**REQUEST FOR CHANGE TO TECHNICAL SPECIFICATIONS
PRESSURE/TEMPERATURE LIMITS
HOPE CREEK GENERATING STATION
FACILITY OPERATING LICENSE NPF-57
DOCKET NO. 50-354**

**REQUEST FOR CHANGE TO TECHNICAL SPECIFICATIONS
PRESSURE/TEMPERATURE LIMITS**

**HOPE CREEK GENERATING STATION
FACILITY OPERATING LICENSE NPF-57
DOCKET NO. 50-354
REQUEST FOR LICENSE AMENDMENT**

Revised Pressure-Temperature Curves for Hope Creek
SIR-00-136, Rev. 1

Figure 3.4.6.1-1
Hydrostatic Pressure and Leak Tests Pressure/Temperature Limits - Curve A

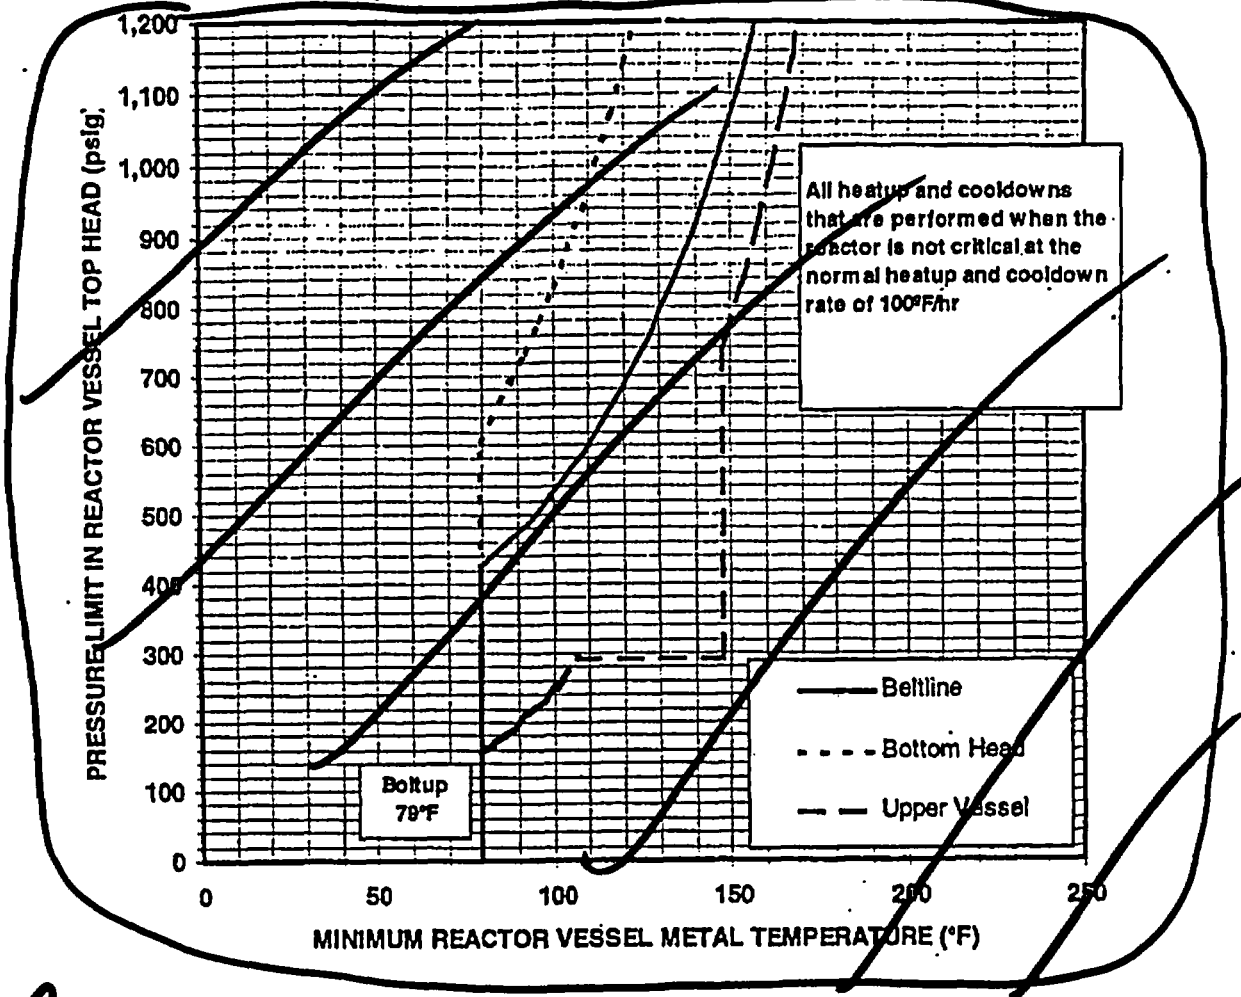
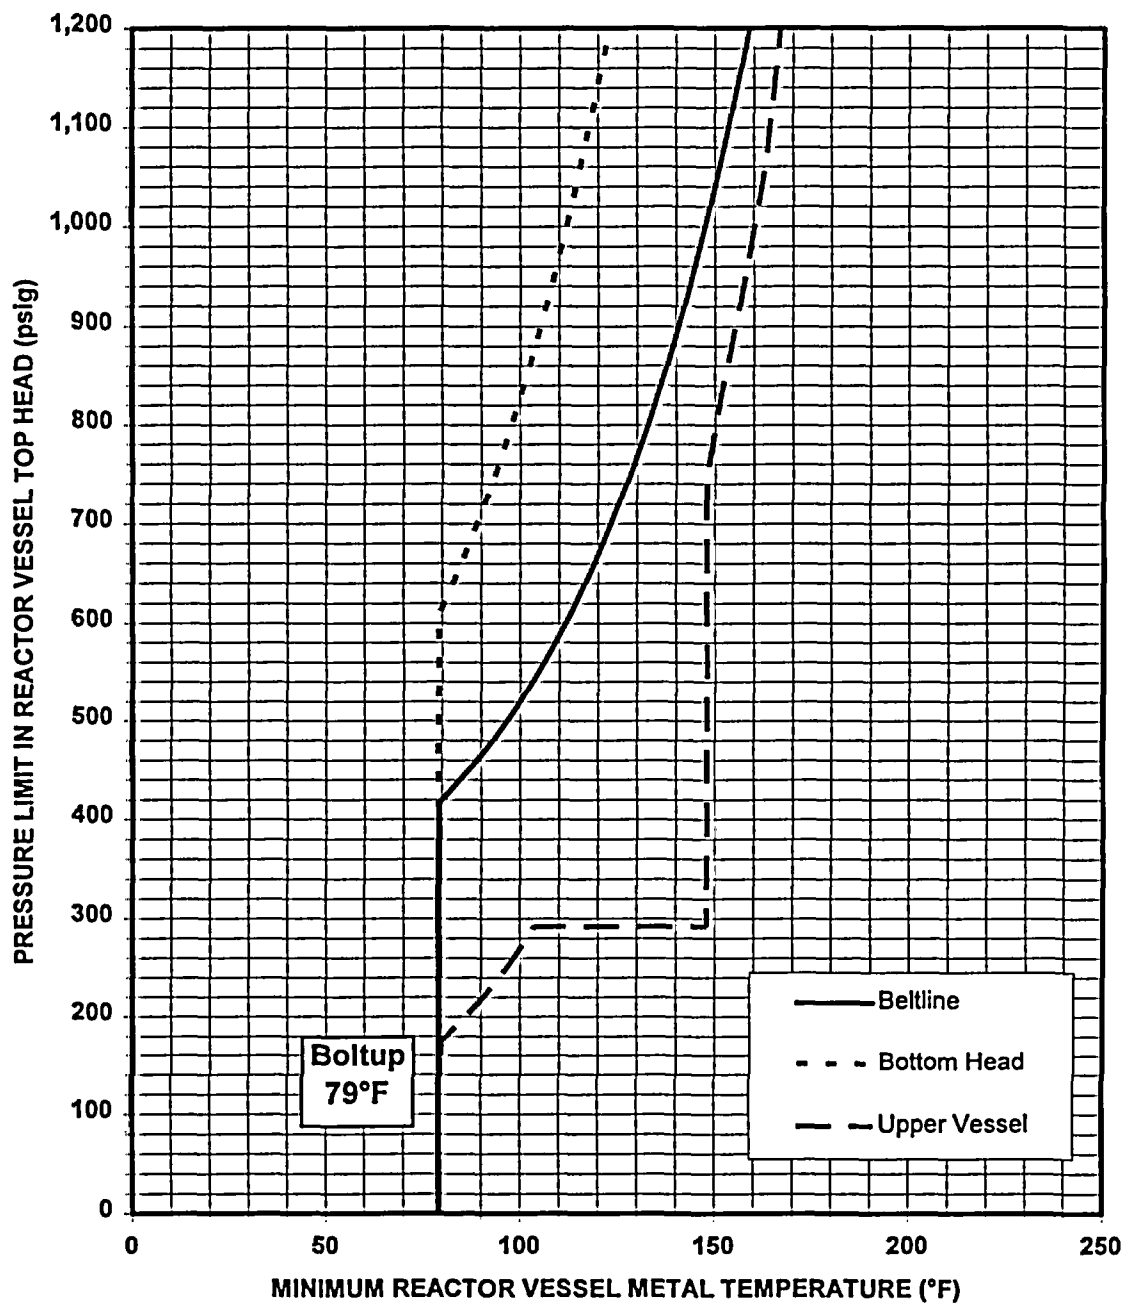
Note: This figure is valid through Cycle 12 Operation in accordance with NRC Safety Evaluation Report supporting Amendment No. 139

INSERT CURVE A

INSERT CURVE A

All system leakage and hydrostatic pressure tests performed during the service life of the pressure boundary in compliance with ASME Code Section XI.

This figure is valid for 32 EFPY of operation.

Non-Nuclear Heatup and Cooldown Pressure/Temperature Limits - Curve B

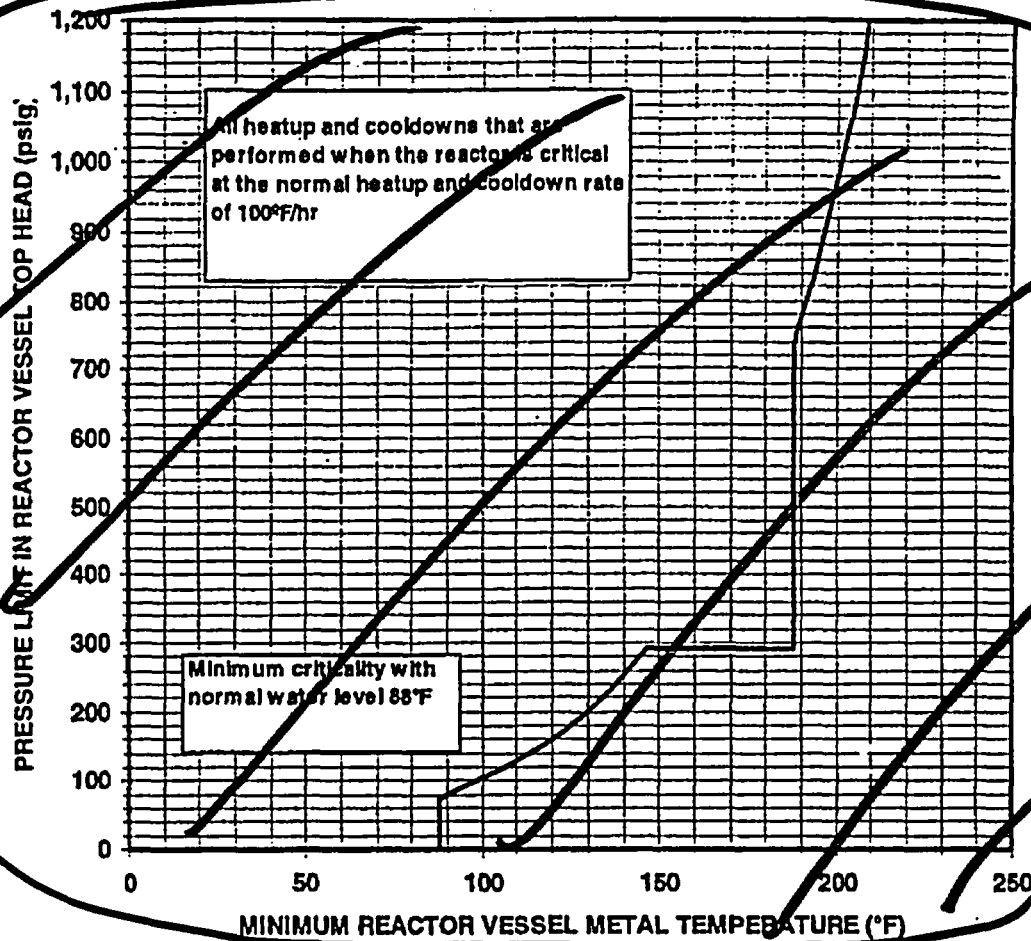
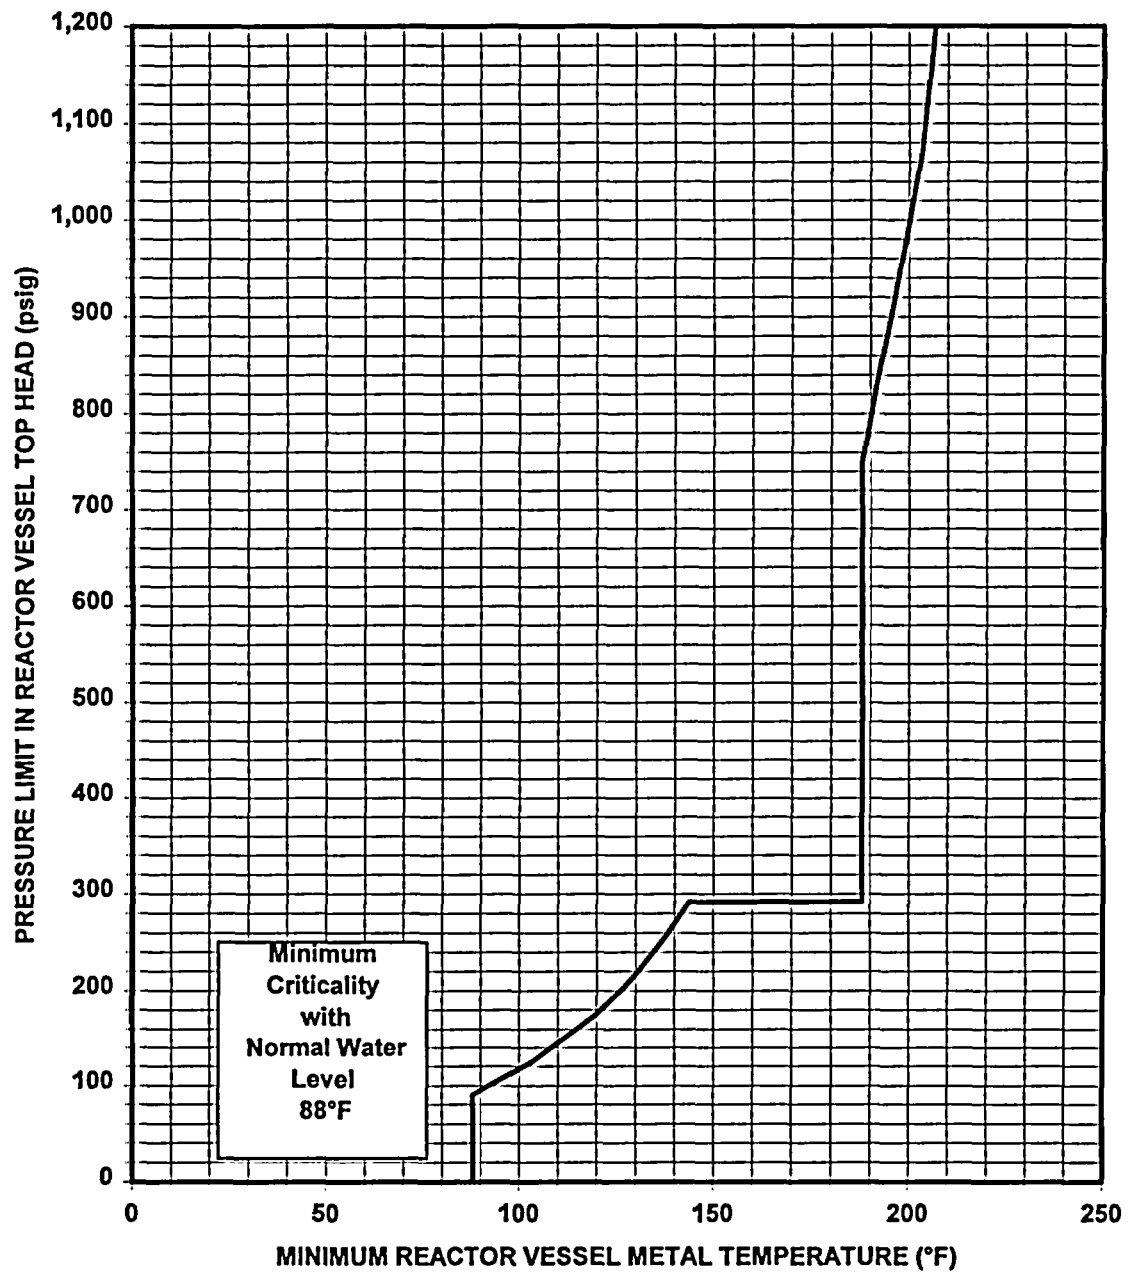
This figure is valid through Cycle 12 Operation with NRC Safety Evaluation Report supporting Amendment No. 139

INSERT CURVE B

INSERT CURVE B

All heatup and cooldowns that are performed when the reactor is not critical at the normal heatup and cooldown rate.

This figure is valid for 32 EFPY of operation.

FIGURE B 3/4 4.6-1 LOWER - INTERMEDIATE SHELL FAST NEUTRON FLUENCE (E>1 Mev) AT 1/4 T AS A FUNCTION OF SERVICE LIFE*

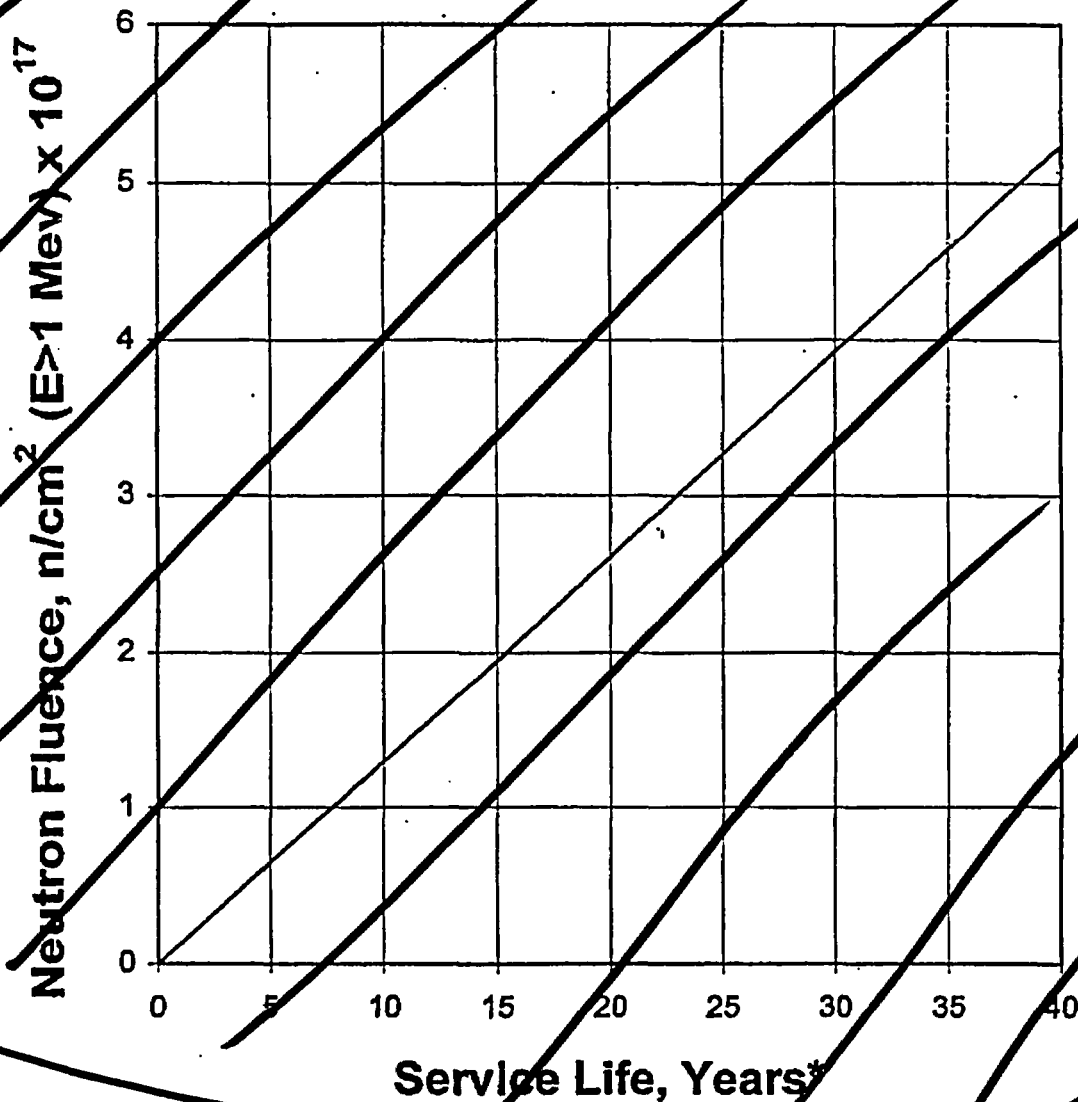
INSERT FIGURE B 3/4.4.6-1

INSERT FIGURE B 3/4.4.6-1

The fluence in Bases Figure B 3/4.4.6-1 was determined using methodology described in NRC-approved General Electric Nuclear Energy Licensing Topical Report NEDC-32983P-A. This methodology is consistent with the guidance in Regulatory Guide 1.190, Rev. 0, "Calculational and Dosimetry Methods for Determining Pressure Vessel Neutron Fluence."

Core Critical Heatup and Cooldown Pressure/Temperature Limits - Curve C

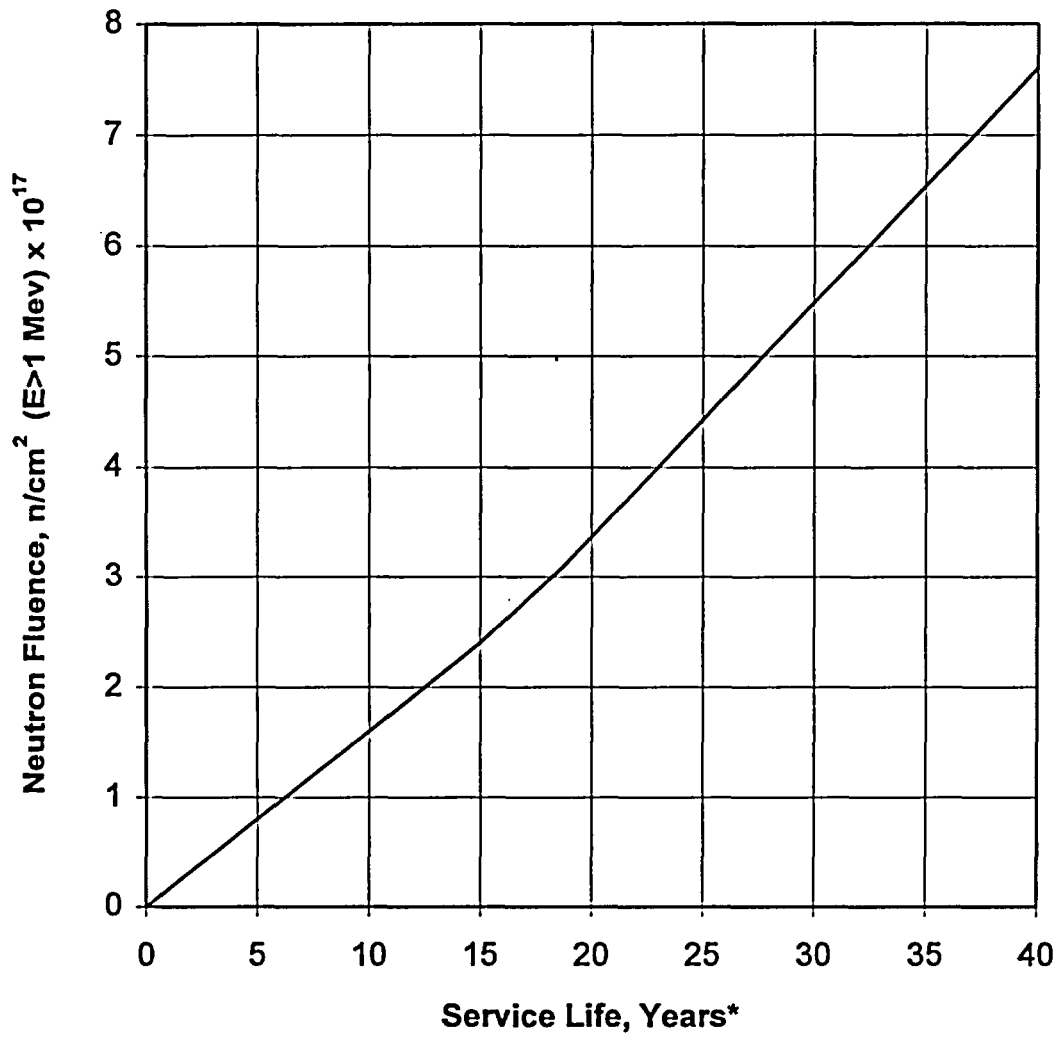
Note: This figure is valid through Cycle 12 Operation in accordance with NRC Safety Evaluation Report supporting Amendment No. 139.

INSERT CURVE C

INSERT CURVE C

All heatup and cooldowns that are performed when the reactor is critical at the normal heatup and cooldown rate.

This figure is valid for 32 EFPY of operation.
